PLANS AND DOCUMENTS
referred to in the PDA
DEVELOPMENT APPROVAL

Approval no: DEV2025/1652

Flood Impact Assessment (FIA) and Stormwater Management Plan (SMP)

197-201 Teviot Road, Greenbank

Figure 6-2 LCC Flood Risk Mapping Overlayed with Proposed Development – Note: This Does Not Show the Final Basin Design.

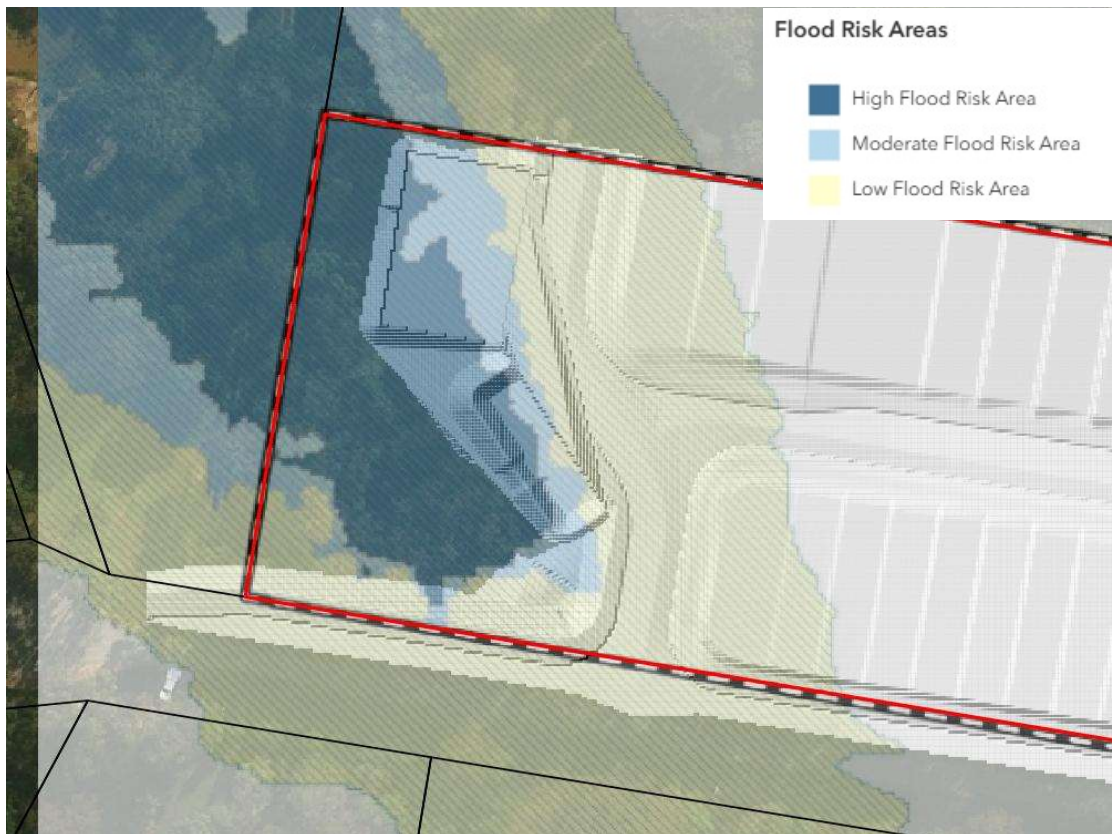
- e) Clarify why lots 38-41 appear to discharge to the driveway surface passing through several private properties and have not been provided with kerb or underground connections to a lawful point of discharge.

- 7d) response – The extent of the earthworks and batters associated with the detention and bio-retention basin with respect to the Council medium/high flood risk area mapping is illustrated in Figure 6-2. It is acknowledged that the batters extend into the high flood risk area identified in the Council flood overlay mapping, which we understand is the context of the reference made by EDQ as to the medium/high risk flood area. Notwithstanding the fact that this application is submitted to EDQ as the assessment manager separate to Council, the following comments are relevantly made:

- Performance Outcome 6 (PO6) of the Council Flood Overlay code provisions allow for the development envelope to be located within a high flood risk area to create a lot for drainage purposes (refer Planning Scheme extract provided in Figure 6-1). The plan of development is inclusive of a Balance Lot 900 which is proposed for drainage purposes and fully encapsulates the proposed detention and bio-retention basin, and which is also practically entirely inundated in the 1% AEP event;
